SUBJECT: Block: 662 Lots: 5

Street Address: 27 Washington Street
Applicant Name: 27 Washington Street Associates, LLC

APPEAL #: 13766

PLANNING REVIEW #2

Figure 4: Example of roof amenity deck.

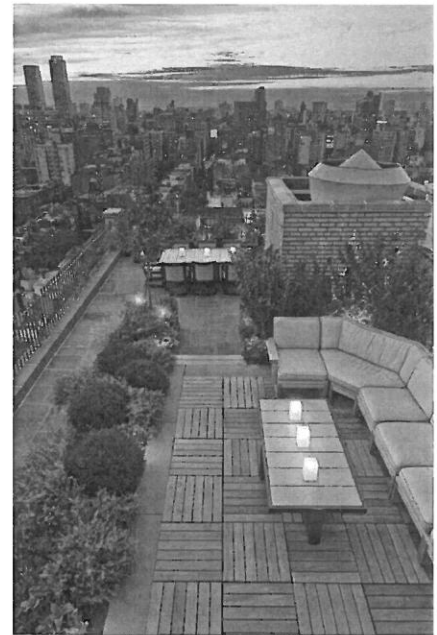
- (2) The architectural plans show a simple layout for the roof "patio" amenity providing three center planters with one or two benches each and three benches along one side of a perimeter planter. Considering the importance placed by the Board in their original approval on the roof amenity space being available to the public, we suggest that greater attention be given to its design so that it functions as an equivalent or superior replacement for the public's use of the passive space currently on the site.
